2006 Cadillac STS-V: Service Bulletin: #07-07-30-002: 6L80 Automatic Transmission Busy Shifting, MIL Illuminated, DTC P1751 Set

#07-07-30-002: 6L80 Automatic Transmission Busy Shifting, MIL Illuminated, DTC P1751 Set (Replace Control Valve Body Spacer Plate) - (Jan 30, 2007)

Models: 2006 Cadillac XLR-V,
STS-V
2006 Chevrolet Corvette
2007 Cadillac Escalade,
Escalade ESV, Escalade
EXT
2007 GMC Yukon
Denali, Yukon Denali XL
Built Prior to December
2006
with 6L80 (RPO MYC)
Automatic Transmission

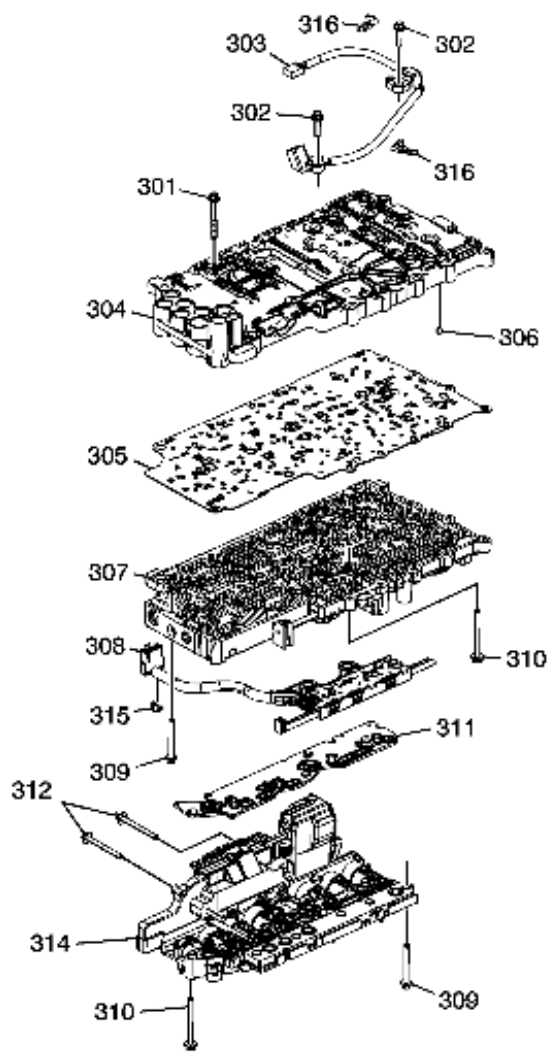
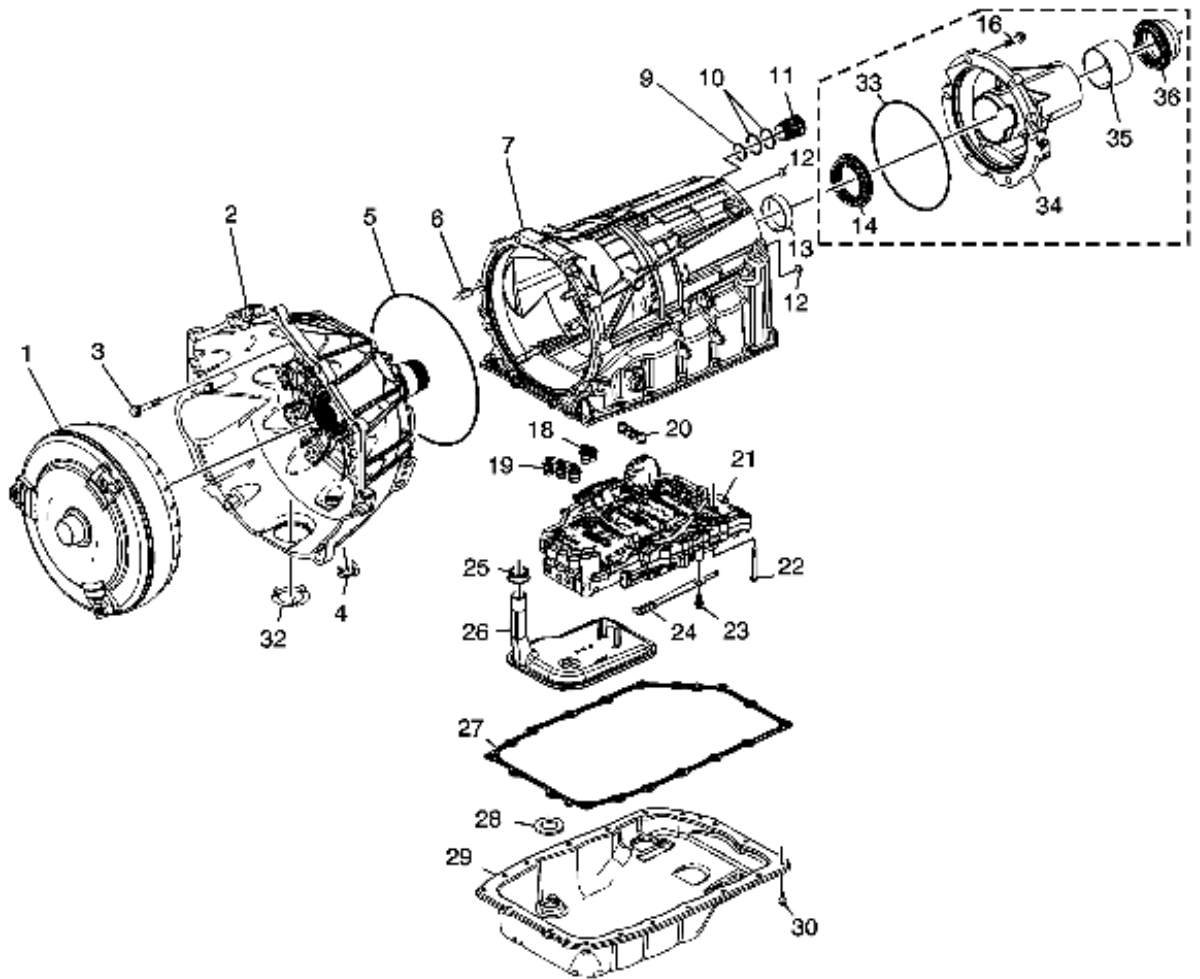
This condition may be caused by an undersized hole or debris in the control valve body spacer plate (305).

To correct this condition the control valve body spacer plate (305) must be replaced. The electrical connector seals (9, 10), fluid pump seals (18, 19), center support seal (20) and the filter plate assembly (311) should also be replaced. These parts are included in the filter plate kit listed below.

Changes to the control valve body spacer plate were implemented November 4, 2006 in transmission assemblies to prevent this condition.
